**AMENDMENTS TO THE DRAWINGS**

### **REMARKS/ARGUMENTS**

# Annotated Sheet Showing Changes

Fig.1

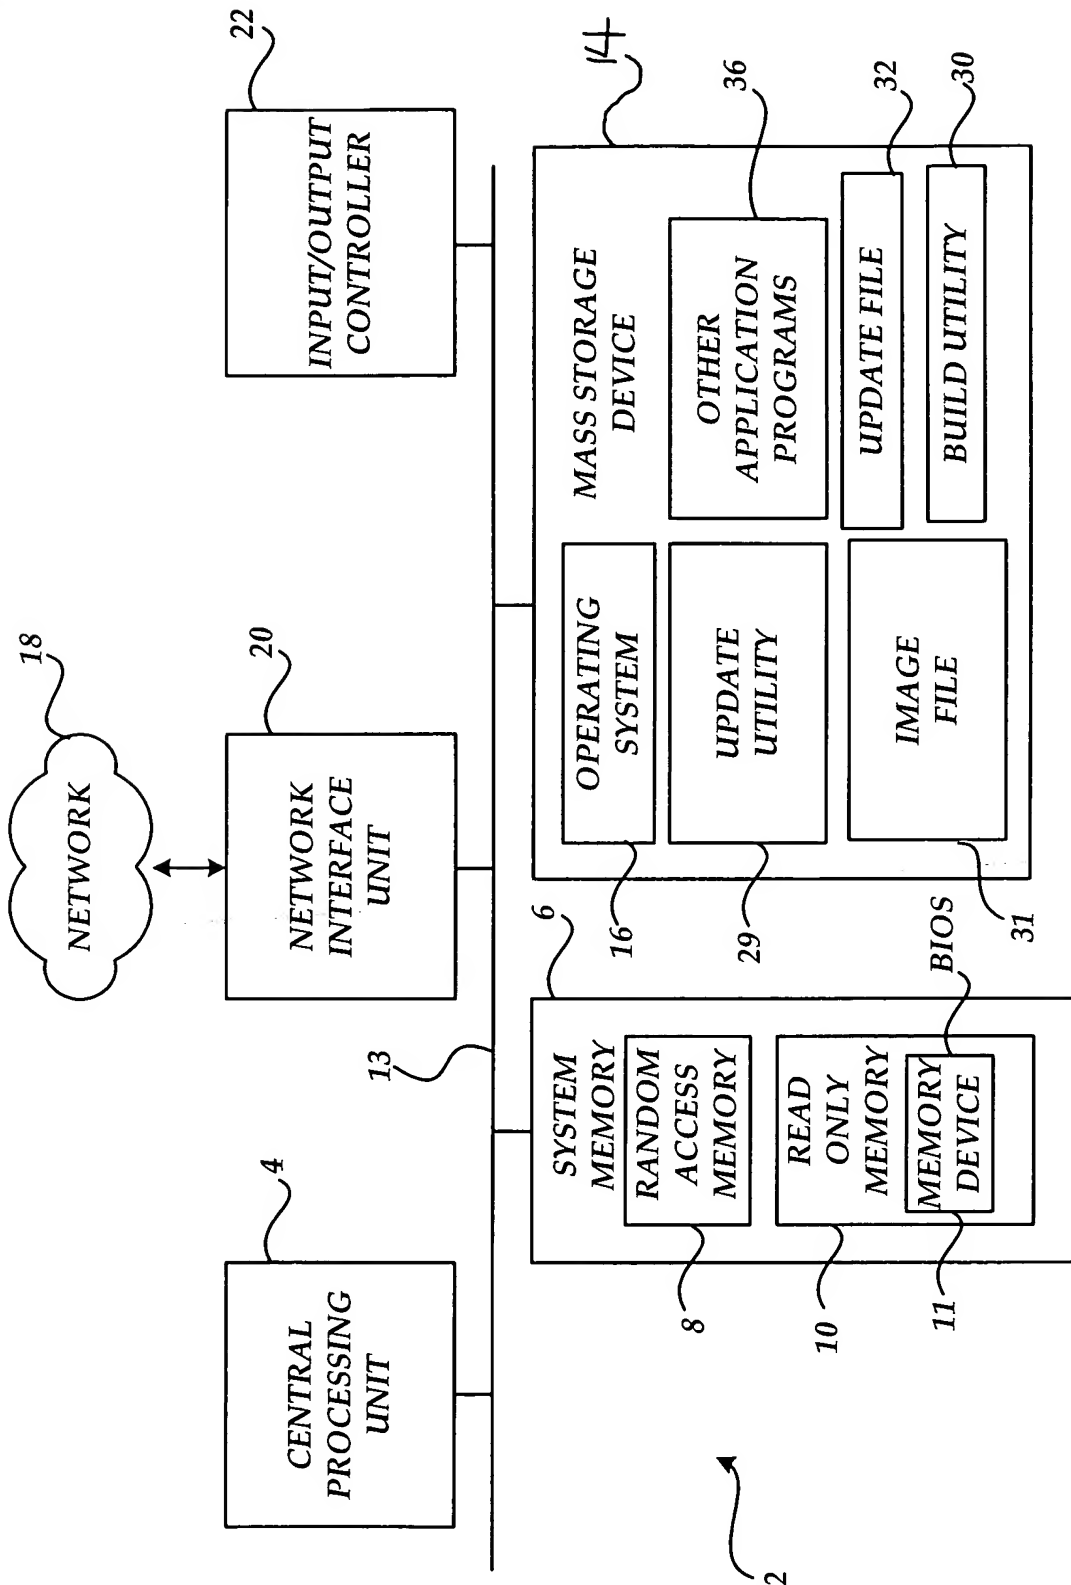
Appendix A includes a Replacement Sheet as well as an Annotated Sheet Showing Changes for Figure 1. The replacement sheet adds item 14, which was inadvertently left off the original figure.

The Action objected to Figure 1 for not showing "mass storage device 14". Accordingly, the applicants have submitted herewith a replacement drawing that corrects the defects noted by the Examiner. In particular, Figure 1 has been amended to include the item number 14 as referring to the mass storage device. No new matter has been added by way of the replacement sheet. Accordingly, the applicants respectfully submit that the objections to the drawings have been overcome and should be withdrawn.
